NEW RESIDENCE
1385 HILLSIDE CIRCLE LOT 1
BURLINGAME, C.A.
A.P.N.: 000-000-000

Kiely Arborist Services LLC
 Certified Arborist WE#10724A TRAQ Qualified
 P.O. Box 6187
 San Mateo, CA 94403
 650-532-4418

ARBORIST REPORT

Showing portion of driveway recommended to be retained until the landscape phase of the project.

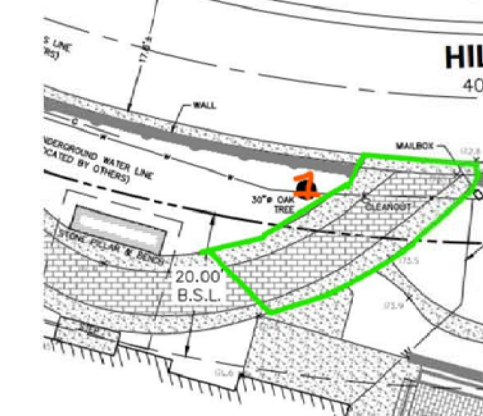
Impacts/Recommendations:
Oak tree #1 is to be retained. The tree is adjacent to an existing driveway. It is recommended to temporarily retain the existing driveway near this tree when underneath the dripline of the tree during the building phase of the project. Temporarily retaining the driveway will act as a tree protection measure and will help to increase staging and access to the site, as removing the driveway at the beginning of the project would make for a larger tree protection zone needed with the fencing being located at the tree's drip line. The existing grade within the tree's dripline is recommended to be retained as is where possible. No grading or excavation is recommended to take place within 10' from this tree (6x diameter) except for the removal of the driveway. At the end of the project, when it is time to demolish the existing driveway near this tree, the Project Arborist is

recommended to be on-site to document and witness the removal of the driveway. A jackhammer is recommended to be used when working within the tree's drip line to break the concrete material into hand manageable-sized pieces. Once broken down the driveway material is recommended to be removed by hand. Exposed roots during the process are recommended to be wrapped in layers of wetted-down burlap to avoid root desiccation. The existing driveway area is recommended to be filled back in once the driveway has been removed so that no roots are exposed to the elements. When backfilling the soil in this area, the area is also to be irrigated. The proposed driveway is further from the tree than the existing driveway and outside of the 10' range and is not expected to have impacts on the tree. The tree is recommended to be deep water fertilized with Nutriroot once the work near the tree has taken place as a mitigation measure for any minor impacts that may take place.

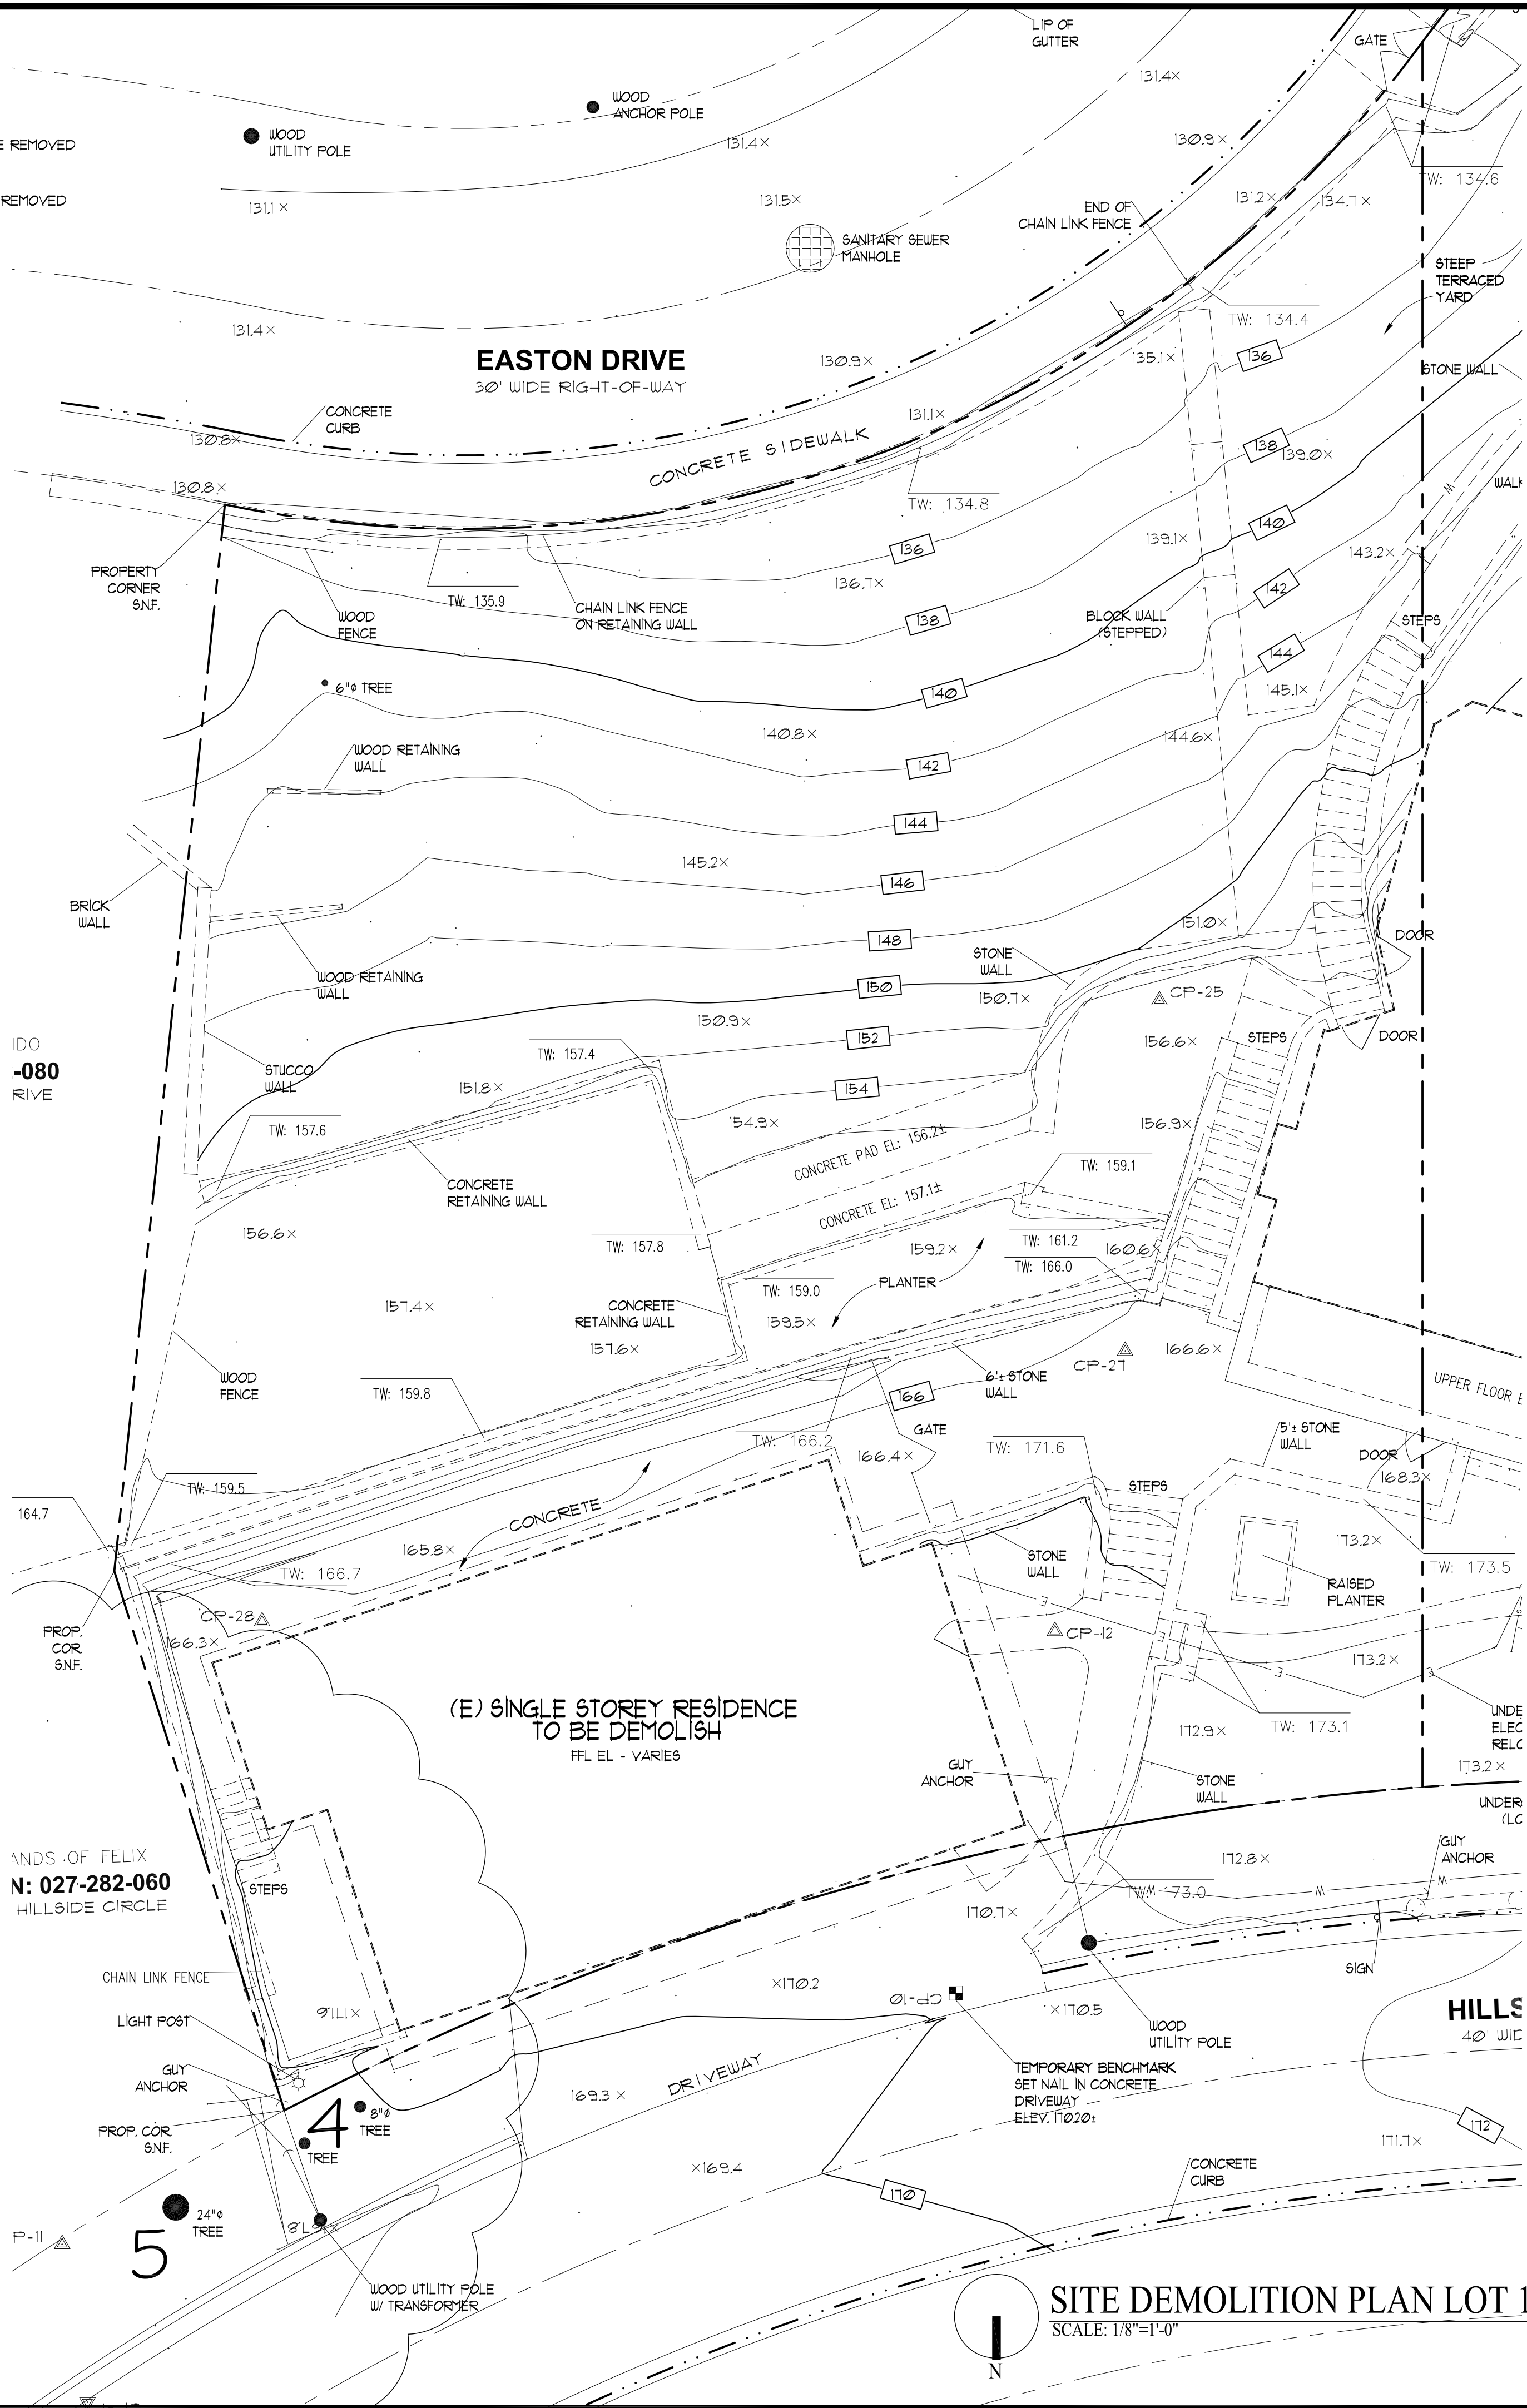
ENSURE THAT TREE PROTECTION SPECIFICATIONS ARE SHOWN GRAPHICALLY ON SITE PLANS FOR CONTRACTOR TO FOLLOW, AS FOLLOWS:

LOCATION OF ALL TREE PROTECTION MEASURES INCLUDING BUT NOT LIMITED TO FENCING, TRUNK WRAP, ROOT BUFFER, ARE TO BE GRAPHICALLY SHOWN ON DEMO PLAN A2 SO THAT CONTRACTOR CAN EASILY INSTALL AND EXECUTE THE TREE PROTECTION MEASURES.

LOCATIONS OF HAND DIGGING AND LOCATIONS OF WORK TO BE UNDER PROJECT ARBORIST SUPERVISION ARE TO BE GRAPHICALLY SHOWN ON THE RELEVANT SITE PLAN SO THAT CONTRACTOR(S) CAN EASILY UNDERSTAND AND EXECUTE THE SPECIFICATIONS. WORK WITH THE PROJECT ARBORIST TO PRODUCE ACCURATE INFORMATION ON THE RELEVANT SITE PLAN. SOME OF THE INFORMATION WILL BE ON THE A SHEETS AND SOME ON THE L SHEETS.

ARBORIST REPORT RECOMMENDS:
RETAINING SOME OF THE DRIVEWAY NEAR TREE 1 AND BREAKING IT DOWN BY HAND LATER IN THE PROJECT. PUT THIS ON DEMO PLAN A2 SO CONTRACTOR CAN FOLLOW IT.
CHANGING THE PATHWAY NEAR TREE 10 TO AVOID ROOT LOSS/DAMAGE. WHERE IS TREE 10? HAS THE PATHWAY BEEN CHANGED?

ARBORIST REPORT IS BASED ON REVIEWING L PLANS DATED JAN 2024, LOT 1 A PLANS DATED 10-26-22, LOT 2 A PLANS DATED 10-26-21 AND LOT 3 A PLANS DATED 10-26-21. NO CIVIL PLANS REVIEWED. NOTE THAT THE CONTENT OF CIVIL PLANS MAY NECESSITATE A CHANGE IN THE ARBORIST RECOMMENDATIONS.

INDICATE THAT AT LEAST 3 SINGLE-TRUNKED LANDSCAPE TREES WILL BE PRESENT ON EACH LOT, AS NOTED BELOW.

PER CHAPTER 11.06, THIS PROJECT REQUIRES 3 SINGLE-TRUNKED LANDSCAPE TREES FOR LOT 3:
TREES MAY BE EXISTING OR NEW.
REQUIRED TREES MAY NOT BE FRUIT OR NUT TREES, PALMS, ITALIAN CYPRRESS OR JAPANESE MAPLE.
REQUIRED TREES MUST HAVE A MATURE HEIGHT OF OVER 15 FEET.
ALL REQUIRED TREES MUST BE IN GOOD CONDITION AT THE FINAL ARBORIST INSPECTION.
STREET TREES DO NOT COUNT TOWARDS THE REQUIRED TOTAL.

PROVIDE THE BOTANICAL NAME (GENUS AND SPECIES) AND LOCATION OF THE REQUIRED LANDSCAPE TREES, AND WHETHER THEY ARE EXISTING OR NEW, FOR EACH LOT.
